October 27, 2015
Medway Planning and Economic Development Board Meeting
155 Village Street
Medway, MA 02053

- Letter dated 10-13-15 from Dario Designs in response to the previous plan review comments/letters from: PGC Associates, Fire Chief, Department of Public Services, Design Review Committee, Open Space Committee and Tetra Tech re: traffic study.

Date October 13, 2015
To Town of Medway Planning & Economic Development
From Dario Designs Inc. and Coneco Engineers & Scientists
Project Salmon Health & Retirement Community
Subject Response to Town Comments

Photos of Charles River Village path/trail
October 22, 2015

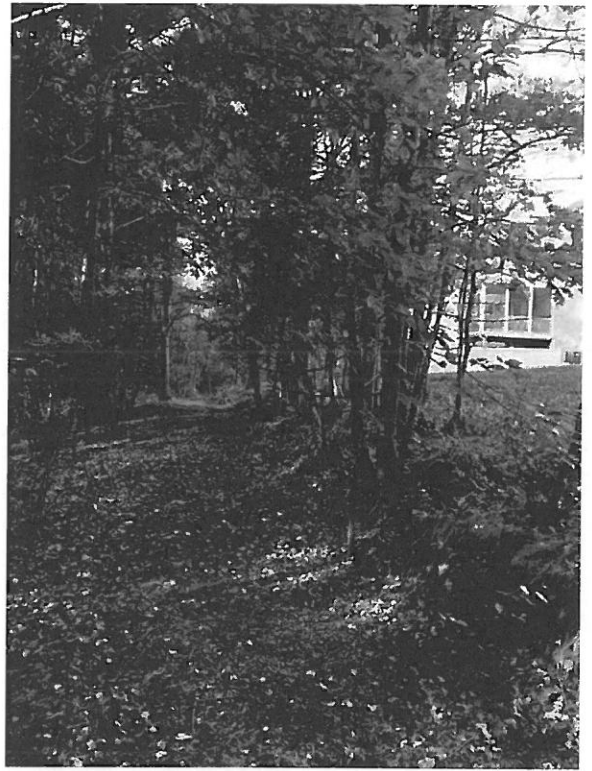
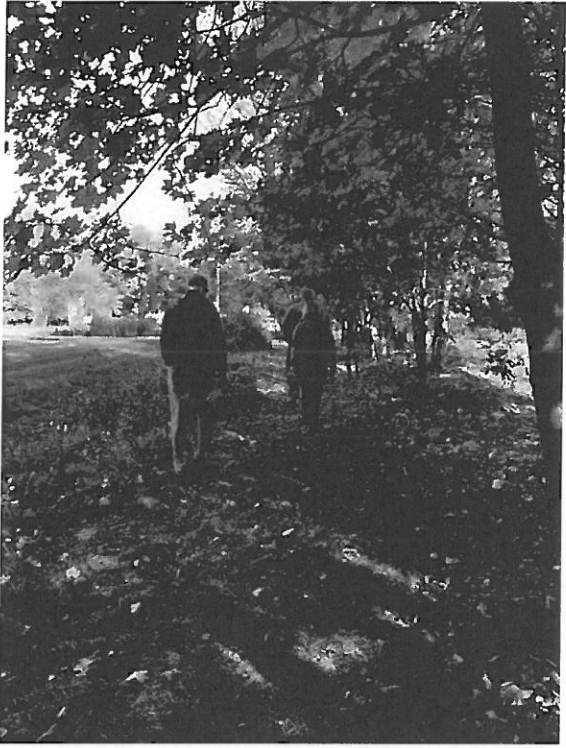
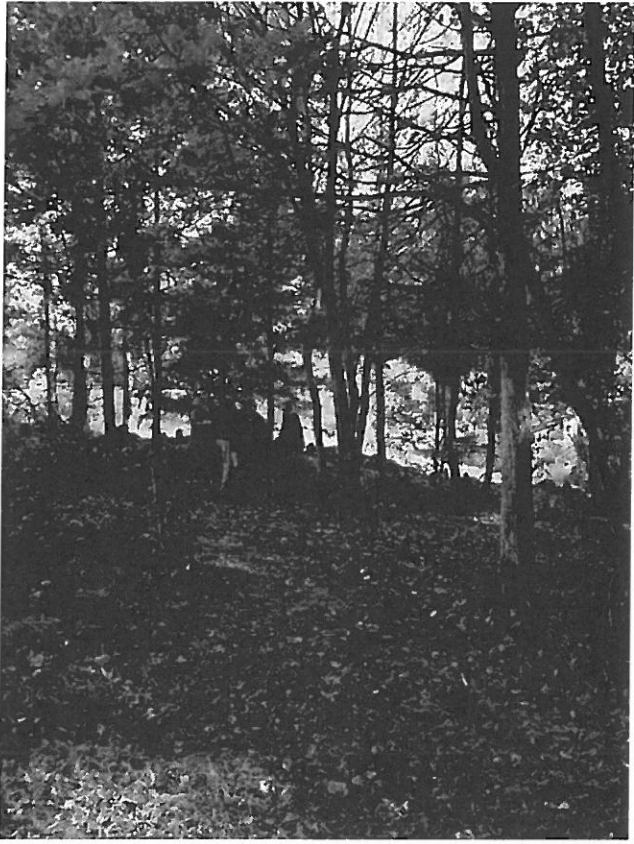
8. The proposed public access trail requires clearing and/or maintenance. It is difficult to determine the extent of the trail as there are no markers or a defined path to walk through. (See Appendix A, Photo #8-#10)
9. It does not appear the boundary markers (iron rod with cap) have been installed or cannot be found. The applicant should locate and/or install all boundary markers per the approved plans.
10. The applicant should ensure that all plantings, as shown on the “Definitive OSRD Planting Plan”, are installed as proposed.
